**A G E N D A**  
**JAMES CITY COUNTY DEVELOPMENT REVIEW COMMITTEE**  
**REGULAR MEETING**  
**Building A Large Conference Room**  
**101 Mounts Bay Road, Williamsburg, VA 23185**  
**June 17, 2020**  
**4:00 PM**

## SITE PLAN-20-0015. Virginia Health Services, Colonial Heritage

Applicant:	Mr. Ryan Kiss
Land Owner:	Virginia Health Services, Inc.
Proposal:	New construction of a +/-160,670-square-foot assisted living facility on one of the commercial parcels of the Colonial Heritage Master Plan.
Location:	6799 Richmond Road
Tax Map/Parcel No.:	2430100032
Project Acreage:	±23.35 acres
Current Zoning:	MU, Mixed Use with Proffers
Comprehensive Plan:	Mixed Use
Primary Service Area:	Inside
Staff Contact:	Tori Haynes, Senior Planner

**TO:** TORI HAYNES, PLANNER  
**FROM:** JOSE L RIBEIRO, SENIOR PLANNER II  
**SUBJECT:** SP-20-0015. VHS WILLIAMSBURG  
**DATE:** 4/6/2020

DRAWN BY: JCS  
CHECKED BY: Checker  
PROJECT #: 1917  
DATE: 03/19/2020  
SCALE: AS NOTED  
SHEET NAME: BUILDING ELEVATIONS - SKILLED NURSING

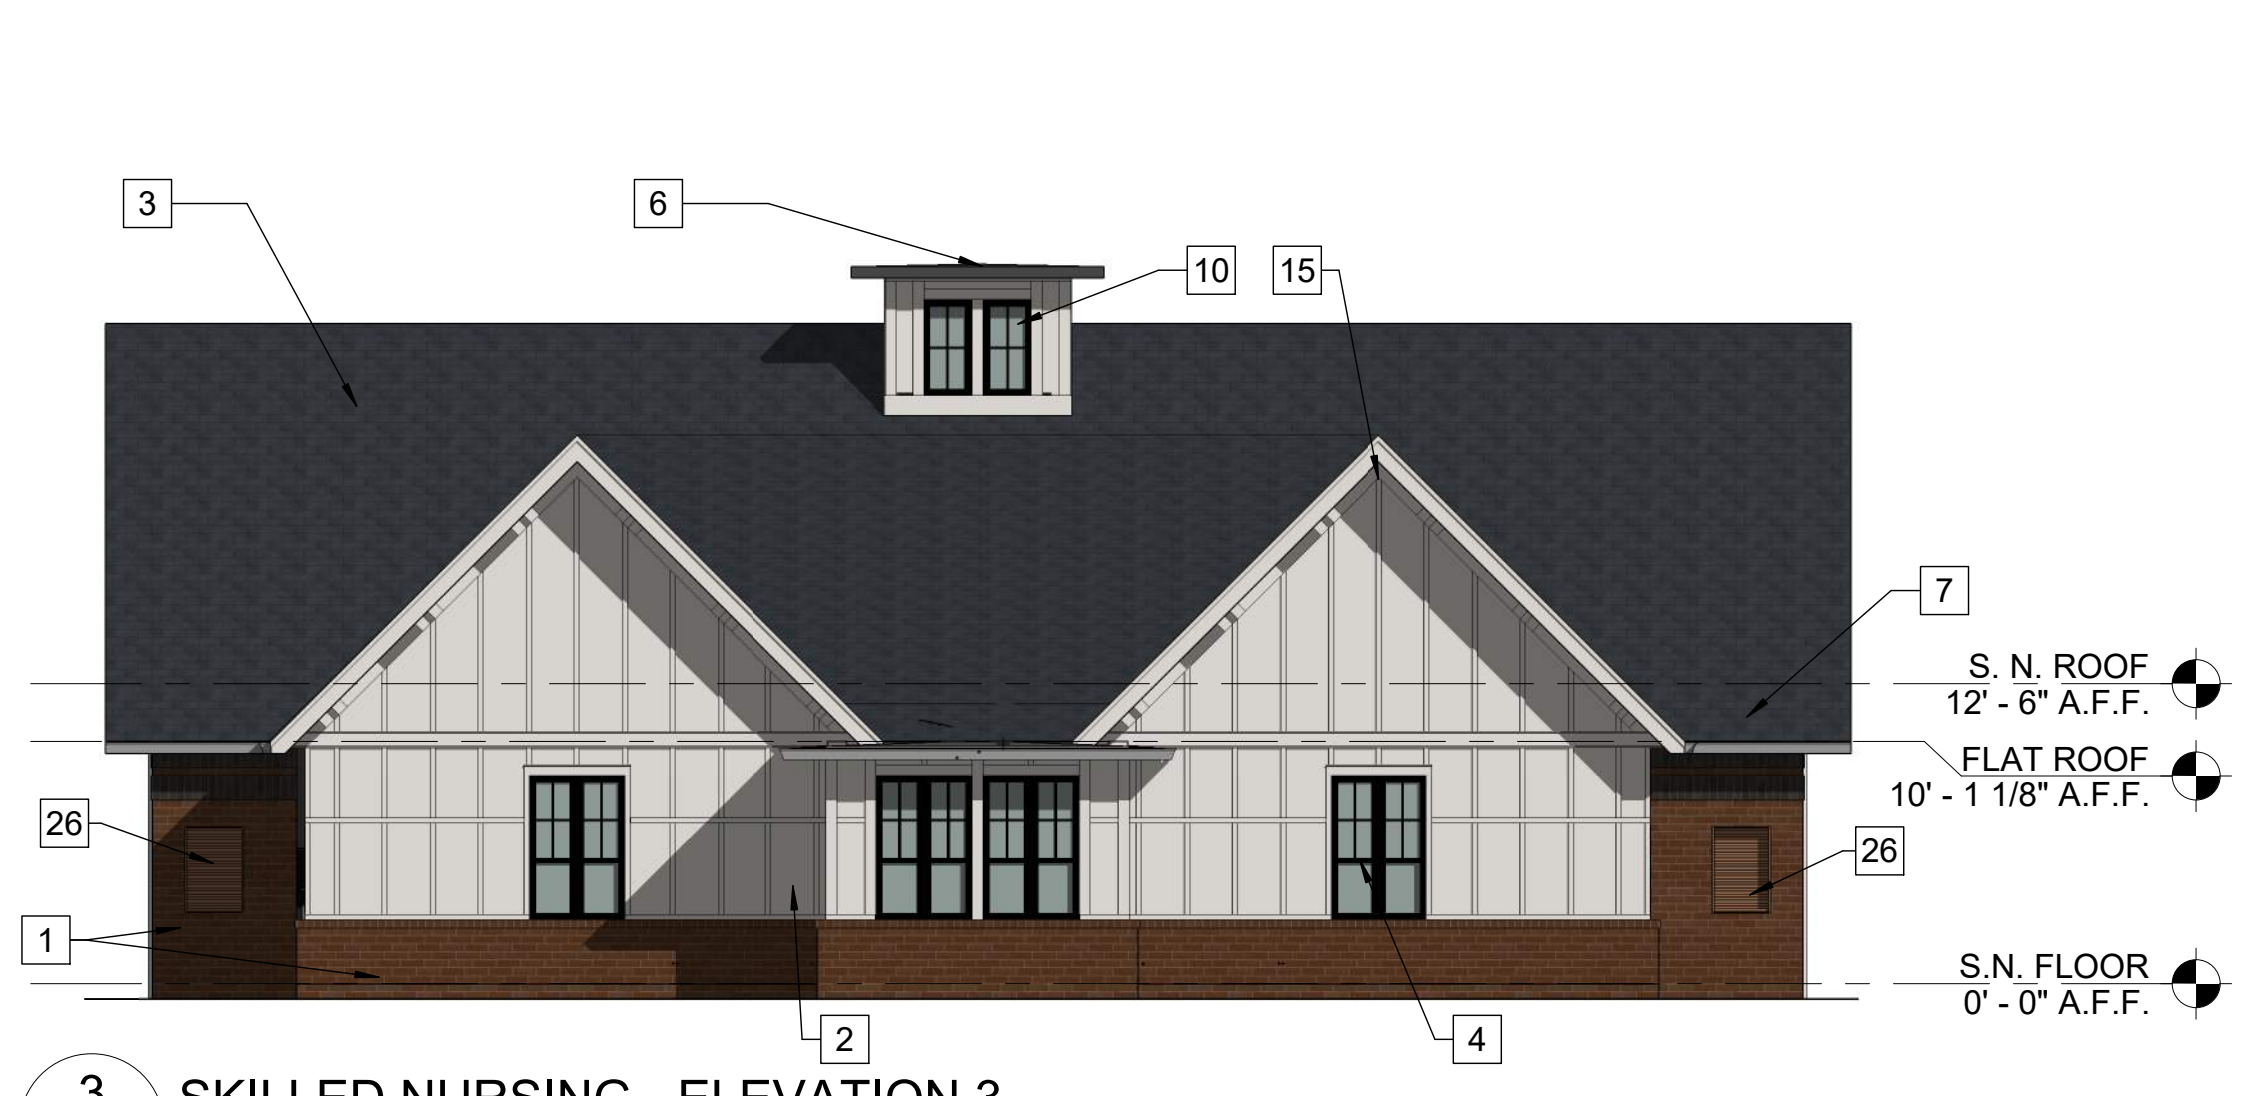
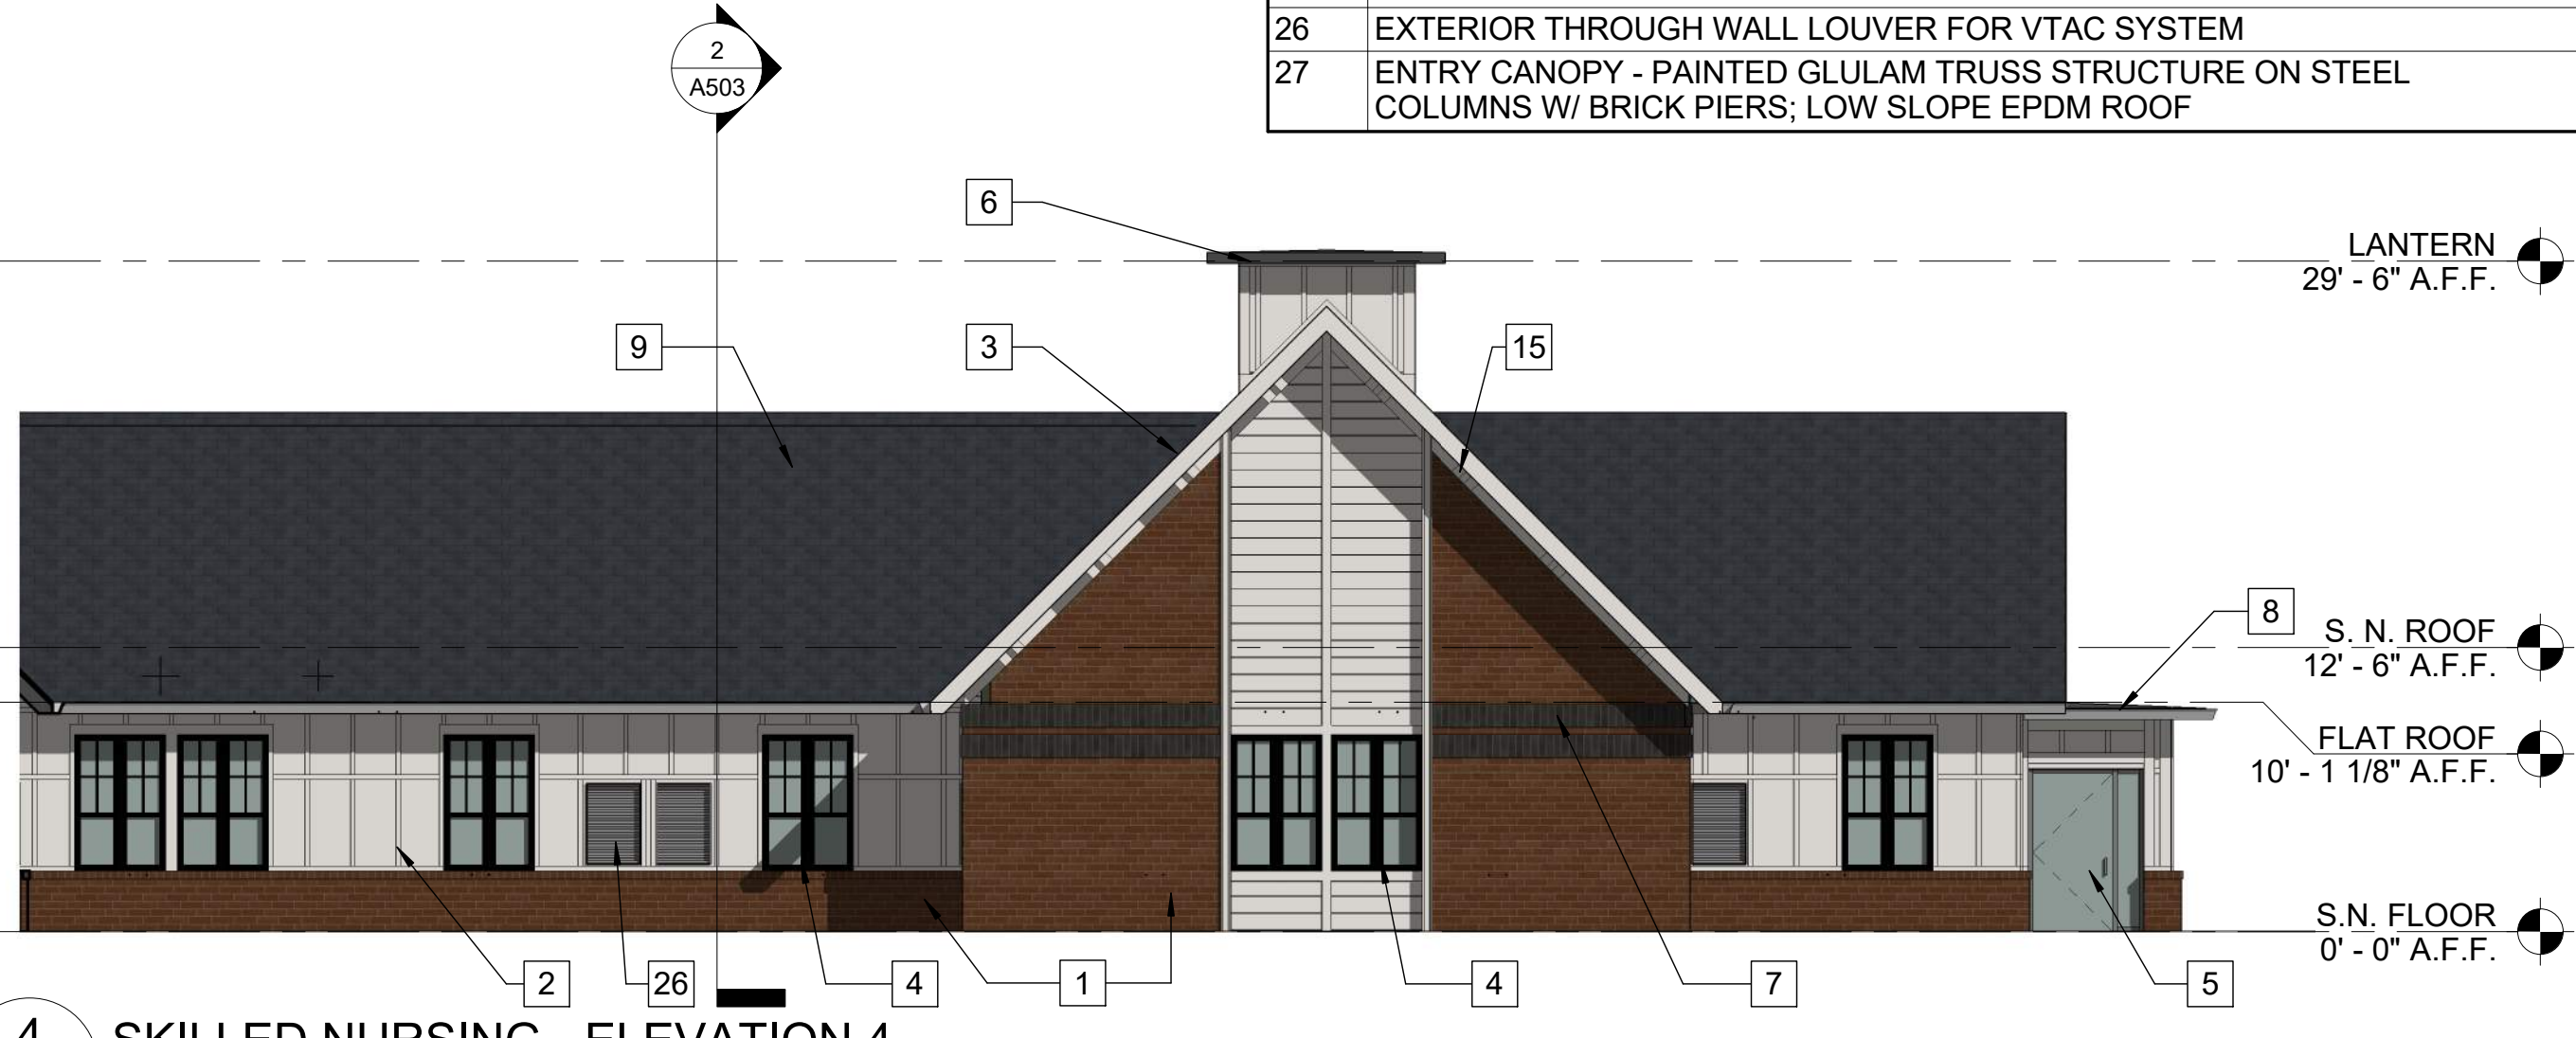
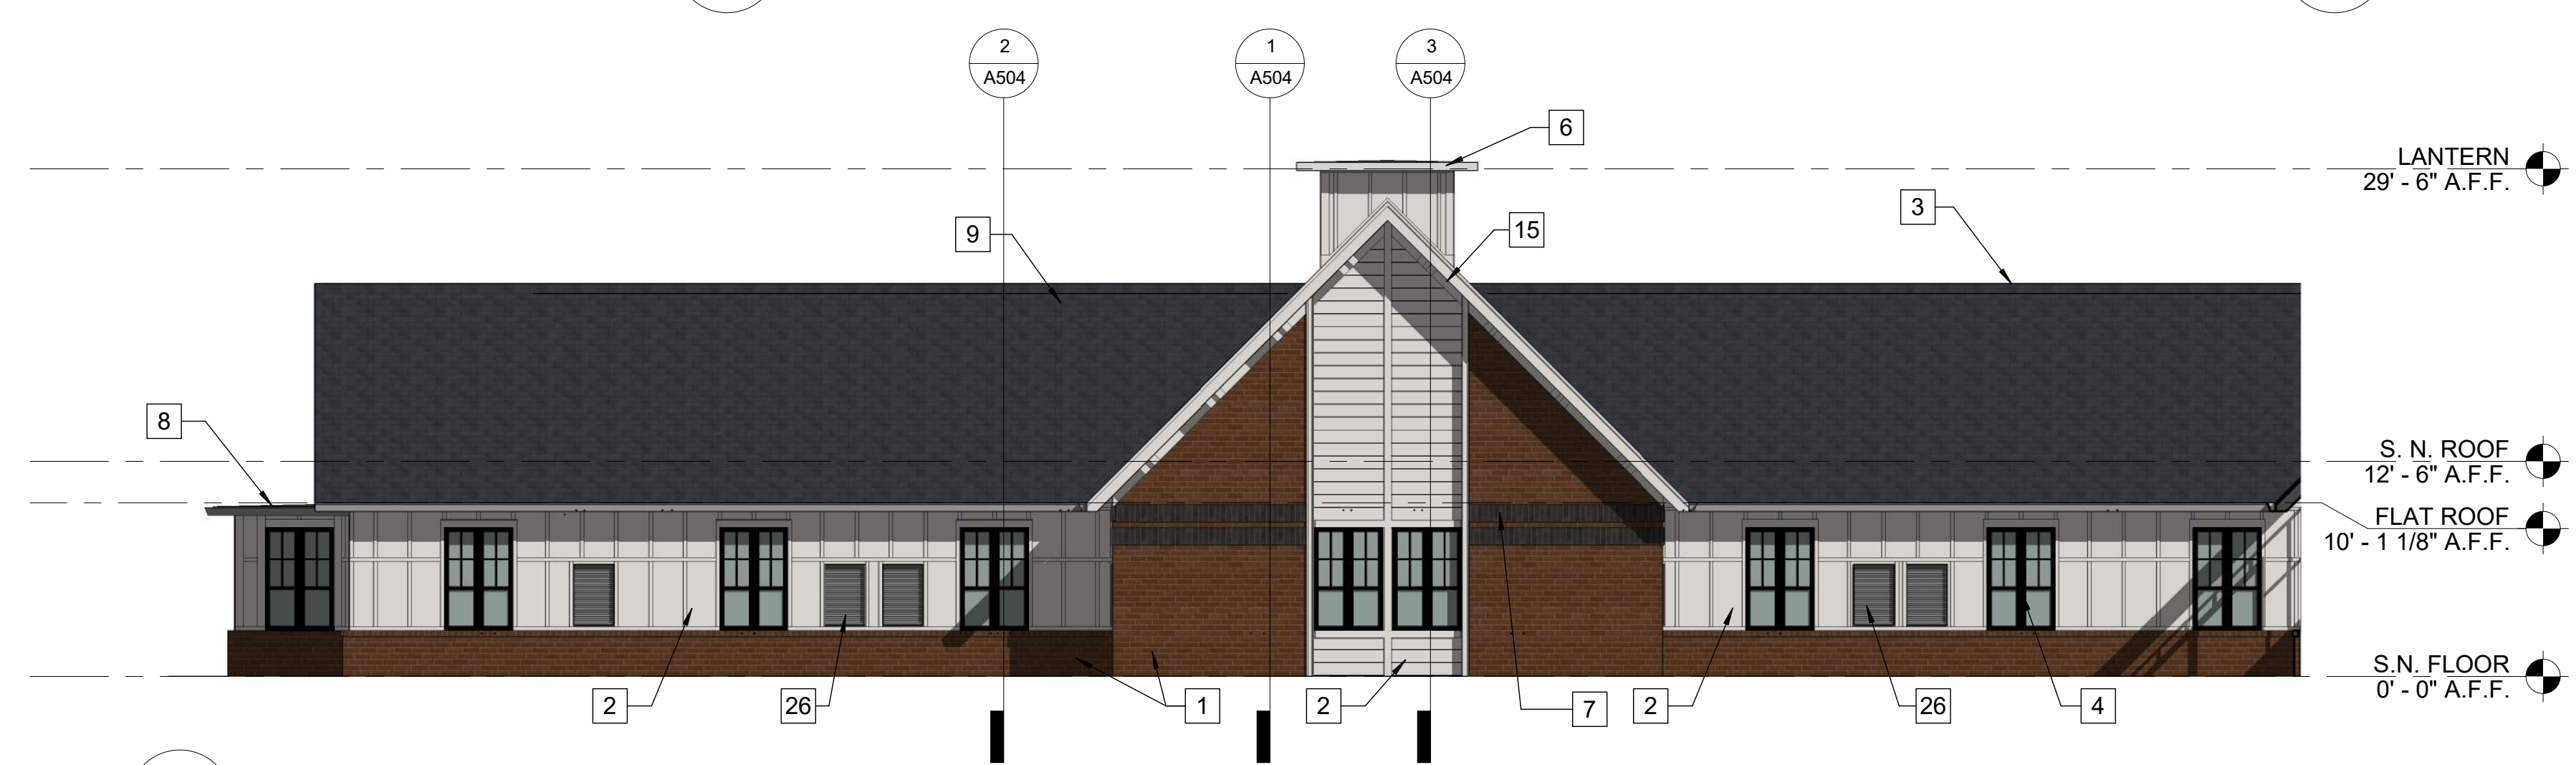
1. Staff finds that the 12/12 roof pitch on the single-story sections as shown in the proposed elevations is not consistent with the approved design guidelines, which show a less severe pitch that is more proportionate to the lower height of a single-story structure.

Staff finds that the elevation design of the one-story sections are generally consistent with these guidelines, with the exception of the roof, which appears to be at a steeper pitch than what is presented in the approved design guidelines (see Attachment No. 4, Page 8, Figure 1.21). While the pitch is not specifically called out in the design guidelines, when comparing the proposed single-story elevations to Figure 1.21, staff determined that the proposed 12/12 roof pitch creates a more severe visual impact relative to the lower height of the single-story sections. Staff did not have this concern on the multistory sections.

Staff recommends that the DRC approve the proposed building elevations, subject to a revised roof design on the single-story sections to achieve more visual balance and to be more consistent with the approved design guidelines, as determined by the Planning Director.

Staff recommends that the DRC recommend approval of the proposed building elevations, subject to a revised roof design on the single-story sections to achieve more visual balance and to be more consistent with the approved design guidelines, as determined by the Planning Director.
